CITY OF ALBUQUERQUE

RE: **Lot 37 Block 6 Volcano Cliffs Unit 18 SAD 228
6615 Sujeto Rd. NW
Grading and Drainage Plan
Engineers Stamp Date 5/12/2020 (D10D003M37)**

PROJECT NAME:		VOLCANO CLIFFS 6615 SUJETO RD NW PULTE ID 24	
SHEET TITLE:		GRADING AND DRAINAGE PLAN	
SUBMITTED FOR:		GRADING PERMIT	
SHEET NUMBER:		1 OF 1

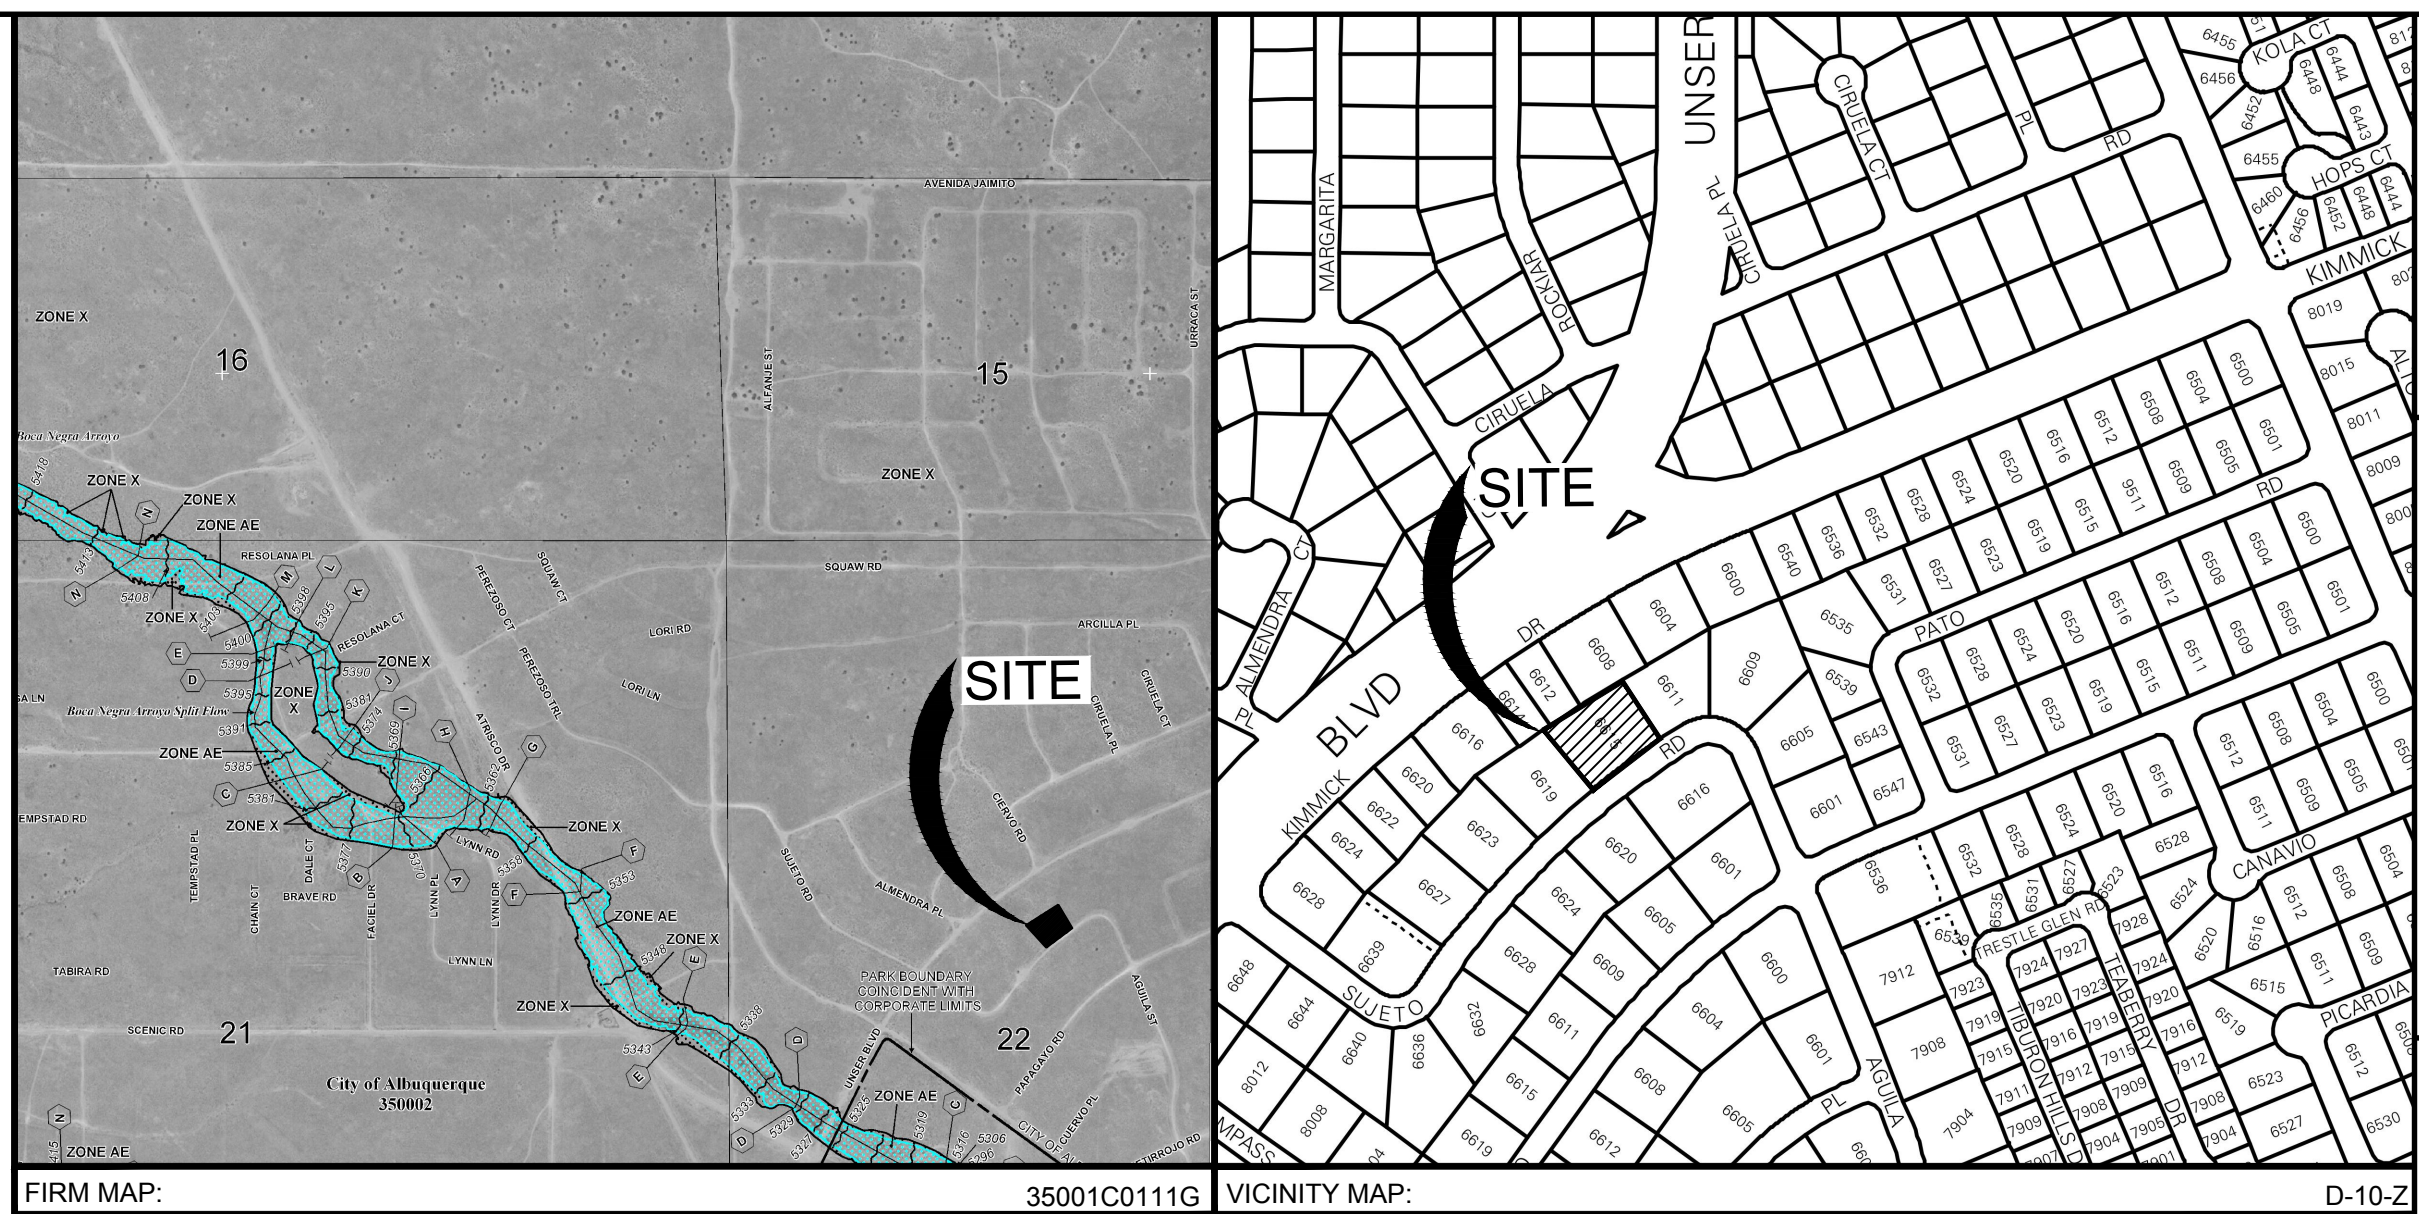
Based upon the information provided in your submittal received 6/17/2020, this plan is approved for Grading Permit.

Prior to Building permit approval a Pad Certification will be required, provided by the Engineer or a registered Land Surveyor.

Reiterate to the Owner/Contractor that a separate permit for a garden/retaining wall must be obtained with the approved G&D plan and Pad Certification. **Also, if a swimming pool is to be placed the grading and drainage plan will change and will need to be resubmitted.**

Prior to Certificate of Occupancy release, Engineer Certification per the DPM checklist will be required.
